TALBOT COUNTY  
HEALTH DEPARTMENT

**APPLICATION FOR SOIL EVALUATION FOR  
ON-SITE WASTEWATER DISPOSAL**

38 Tax Map      17 Block      11 Parcel      Perc Site 1 Lot Number      \_\_\_\_\_ Section

Sites  
P2, M2

Drainage, slope patterns, site locations,  
 Drainage area, etc. (see attached sketch  
 On reverse)

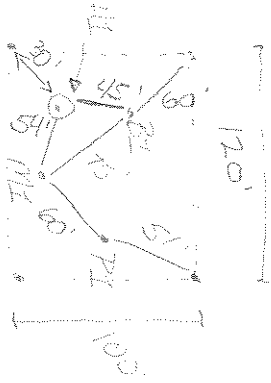
Additional Comments: The SDA may need to be shifted on the plat once reviewed by this office

Recommended shift S.M. on Plat away from  
BL towards Runway to 70'  
Test depth 11' Deep tests Favor 18" BGS
